ADDENDUM #2

NOTICE TO ALL BIDDERS FOR
CITY OF WINCHESTER

ITB #202005 – Valley Avenue Improvements

PROJECT	SHEET NO.
U000-138-R04	20(15)

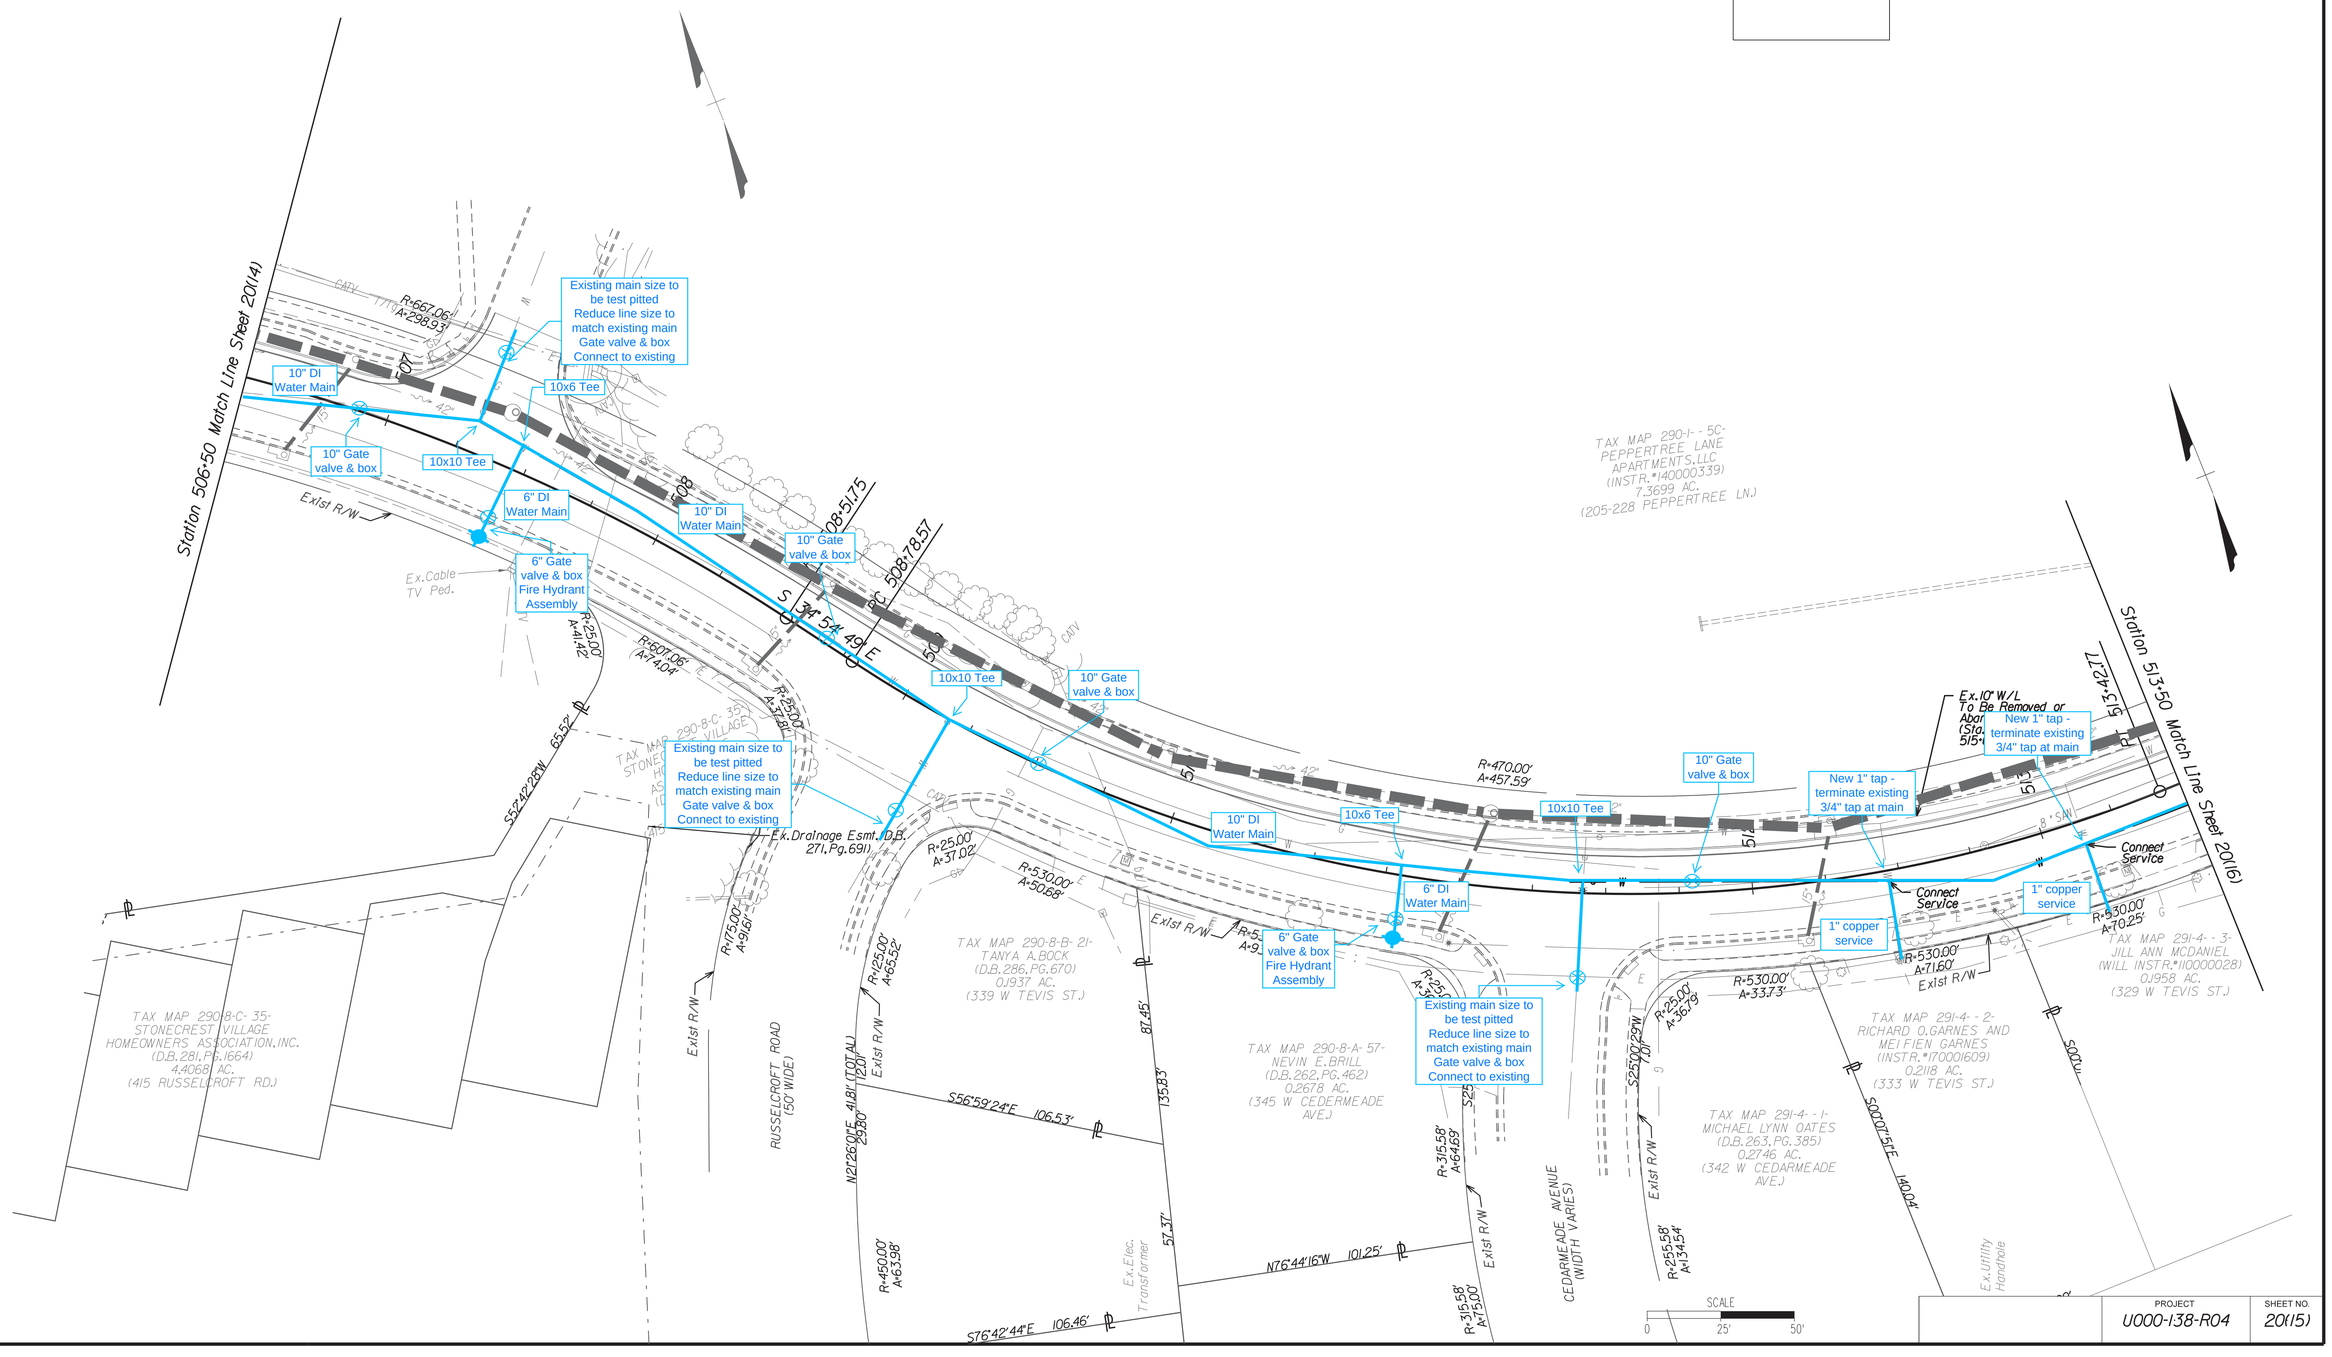
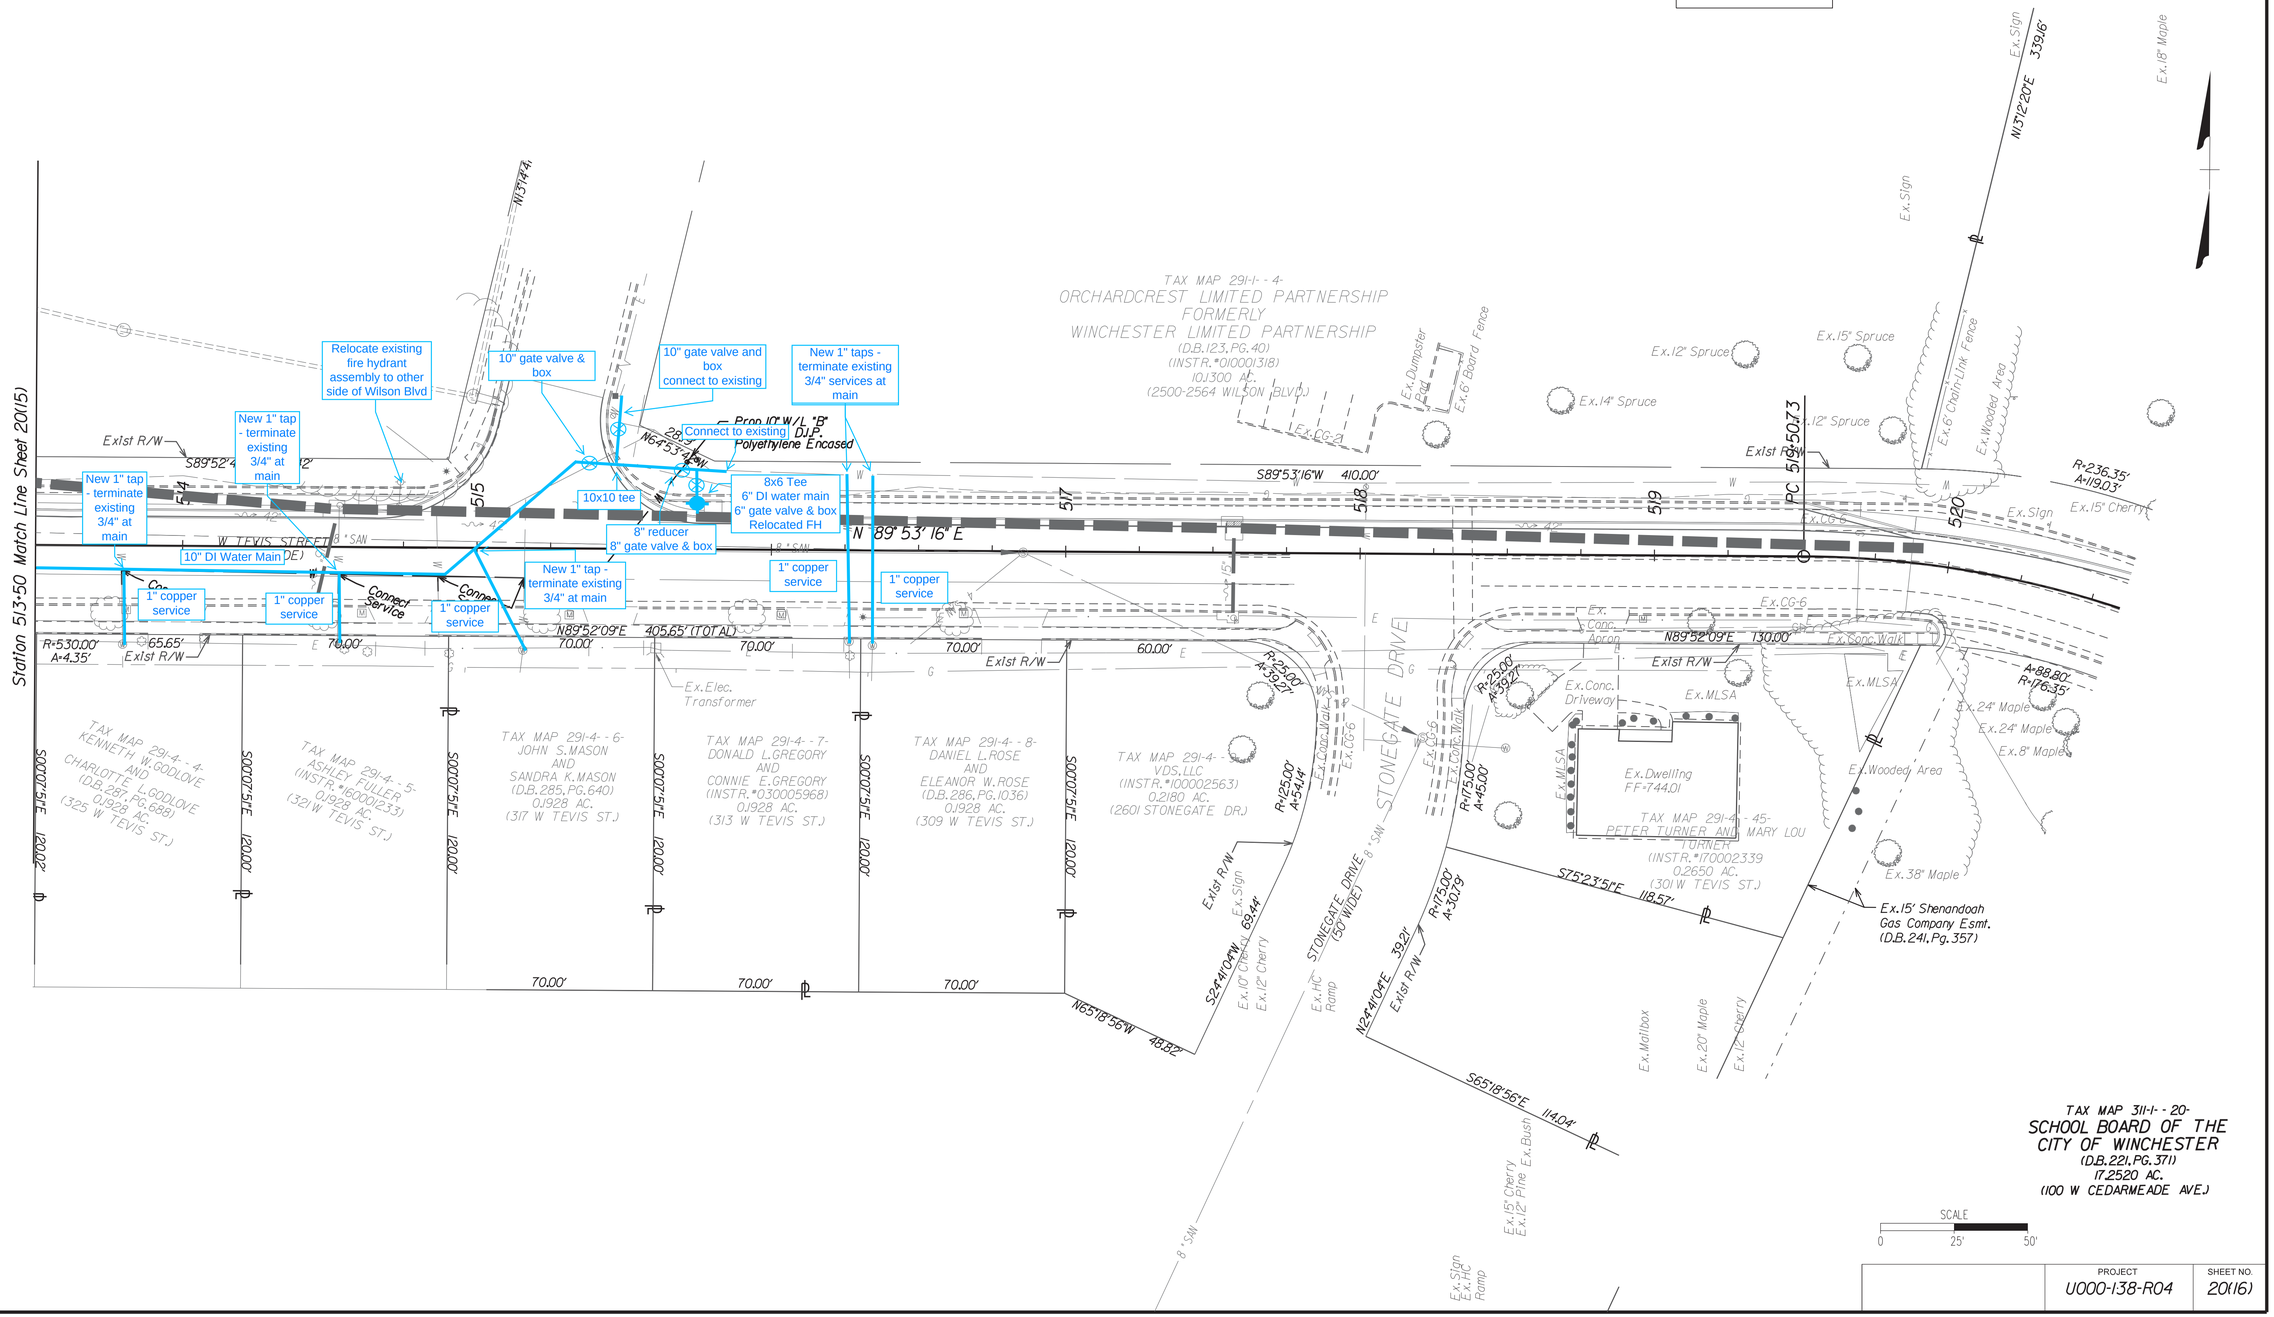
6. There have been numerous additions made to the water and sewer replacements for this project that are included in the revised Bid Form. The original plans have been modified with color showing this information and are attached.
